Work Order ID 91969

Item ID: D3954-5 Accept ***N900040100*** Setup Start ***NS1***
 Revision ID: Stop ***NS2***
 Item Name: Chain Lug
 Start Date: 10/15/12 Start Qty: 6.00 ***6*** Cust Item ID:
 Required Date: 11/09/12 , Req'd Qty: 6.00 ***6*** Customer:
 Reference:

DESIGN	AJS/DSTOW	DART AEROSPACE LTD	
DRAWN	DC	HAWKESBURY, ONTARIO, CANADA	
CHECKED	DE	DRAWING NO.	REV. D
MFG. APPR.	DE	D3954	SHEET 3 OF 3
APPROVED	DE	TITLE	SCALE
DE APPR.	N/A	MISC MACHINED PARTS GWT KIT	NTS
DATE	12.08.10	COPYRIGHT © 2009 BY DART AEROSPACE LTD THIS DOCUMENT IS PRIVATE AND CONFIDENTIAL AND IS SUPPLIED ON THE EXPRESS CONDITION THAT IT IS NOT TO BE USED FOR ANY PURPOSE OR COPIED OR COMMUNICATED TO ANY OTHER PERSON WITHOUT WRITTEN PERMISSION FROM DART AEROSPACE LTD

D3954-5 CHAIN LUG

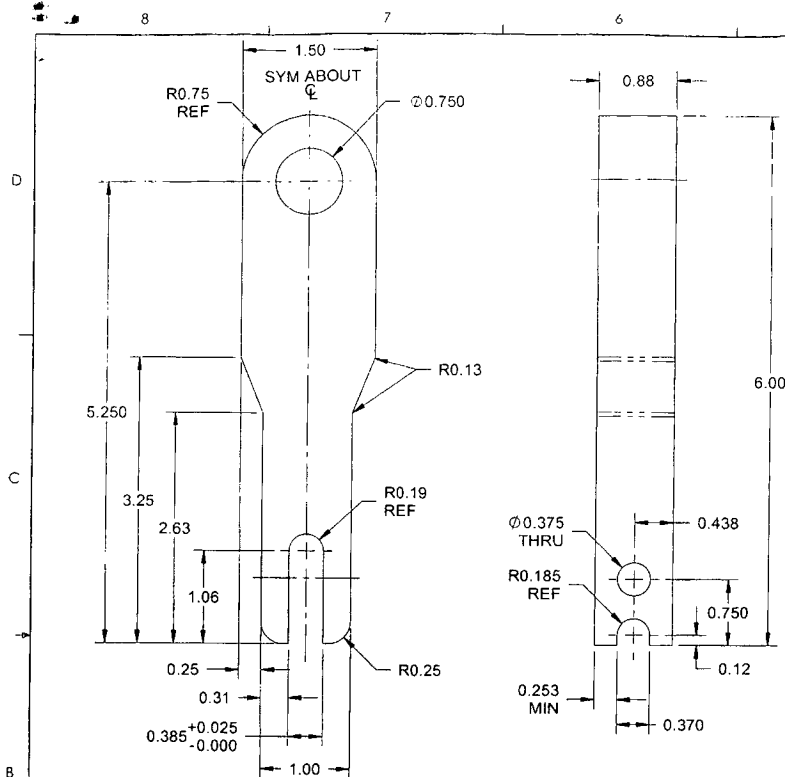
Root Cause	Date	Step	Qty	Description of work order update or Non-conformance	Initial Chief Eng	Action Description	Sign & Date	Verification	QC Inspector
<div style="display: flex; flex-direction: column;"> <div><input type="checkbox"/> Doc/Data</div> <div><input type="checkbox"/> Equip/Tooling</div> <div><input type="checkbox"/> Operator</div> <div><input type="checkbox"/> Material</div> <div><input checked="" type="checkbox"/> Setup</div> <div><input type="checkbox"/> Other</div> <div><input type="checkbox"/> Process</div> <div><input type="checkbox"/> Supplier</div> <div><input type="checkbox"/> Training</div> <div><input type="checkbox"/> Unapproved</div> </div>	12/11/08	125	3	DIM 5.250 IS ACTUALLY 5.240	DAs 22 12/11/08	ACCEPTABLE DEVIATION. LUG ATTACHMENT HOLE TO EDGE DISTANCE IS GREATER WHICH IS STRUCTURALLY BETTER.	JD 12-11-08
